Planning Commission Study Session

31 – 57 S. B Street Pre-Application (PA-2021-082)

May 10, 2022

Zoning Reclassification

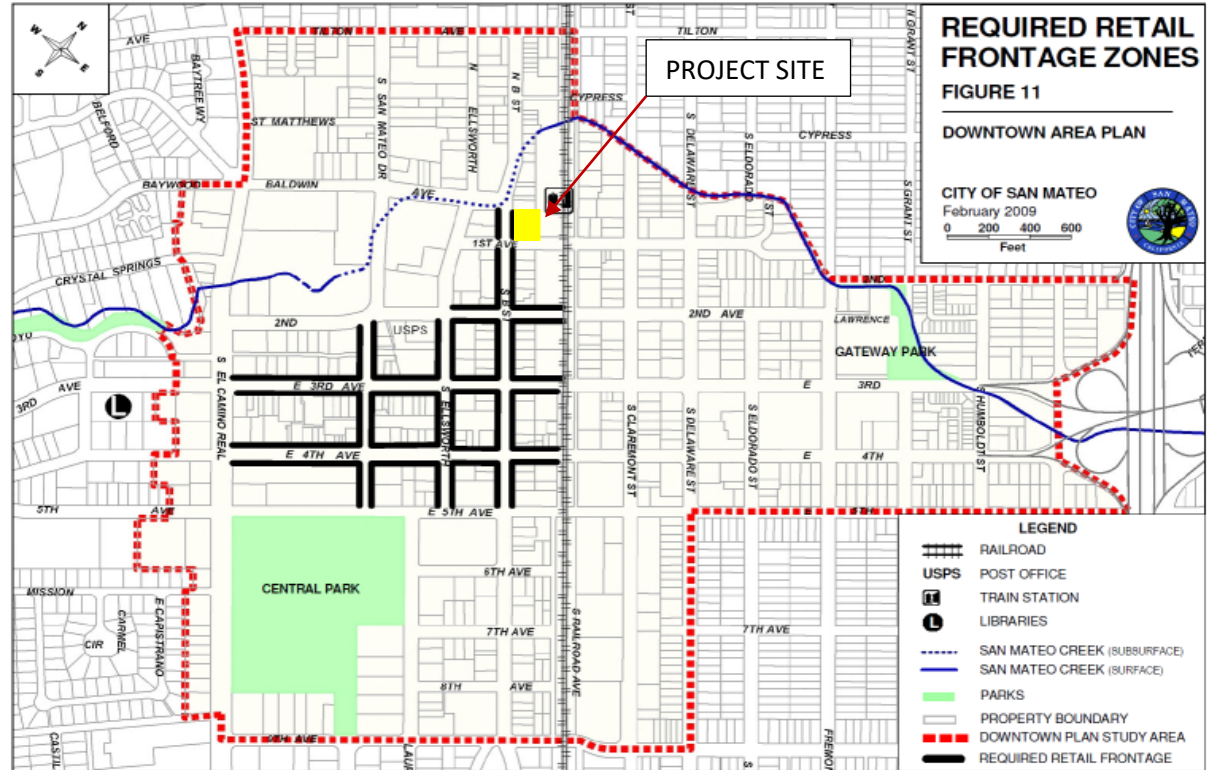
- No Required Retail Frontage Zone or Ground level open space requirements

- Subject to Required Retail Frontage Zone & Ground floor open space requirements

Building Design

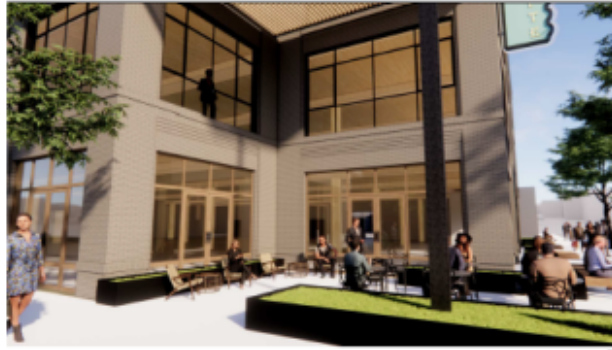
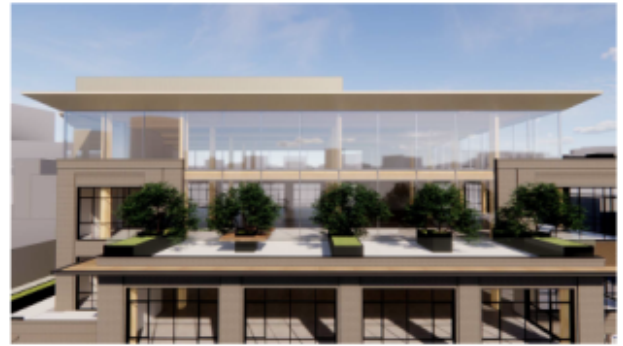
- *Would the Planning Commission recommend improving the proposed project design to address the following:*
 - *Relate height of new buildings to pattern of Downtown;*

- *Design building fronts that recognize the traditional lot widths in Downtown;*
 - *Incorporate key architectural elements common to not buildings in Downtown;*

- *Incorporate architectural detailing that is in scale with human proportions, adds interest and create three dimensional appearance to the building face;*

- *Incorporate recessed entrances to provide for window shopping, pedestrian standing room and protection from wind and rain;*
 - *Incorporate different window sizes with larger windows at the ground floor to enhance the ground floor commercial uses and smaller windows on upper levels to distinguish it as a different use;*

- *Utilize awnings/canopies to add depth to ground floor storefronts and provide location for future signage; and*
 - *Incorporate design elements that provide for alley that is architecturally attractive, safe and inviting for pedestrians, and accommodates the necessary back of house services and loading?*

Pedestrian Master Plan

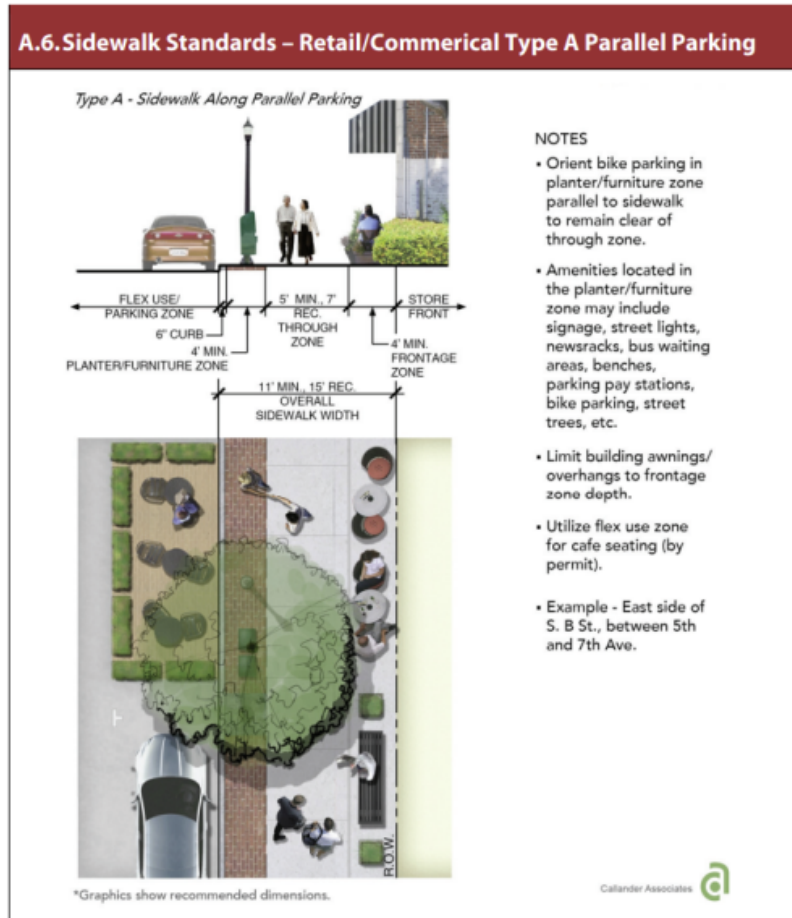
- Master Plan: 11 – 15 ft. sidewalk envisioned
- Proposed:
 - B St sidewalk: ~16 ft - 22 ft
 - First Ave sidewalk: ~8 ft – 24 ft
 - Expand into parking, travel lane

- Should the proposed sidewalk width be 11' to 15' to align with the Pedestrian Master Plan, or should a wider sidewalk be considered?
- If wider sidewalks are desired, should that additional width be created in the public ROW, on private property or combination of both?

Bicycle Master Plan

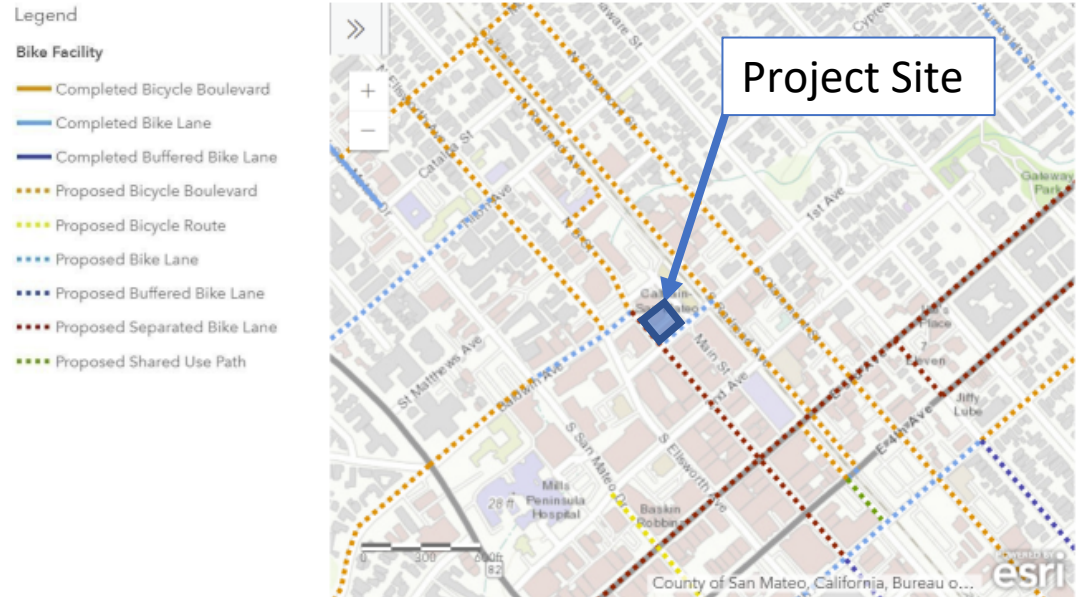
- Future bicycle lane along First Ave.
- City project
- Along B St – future CC ss on future of B St
- Potential conflict with sidewalk expansion into the right-of-way
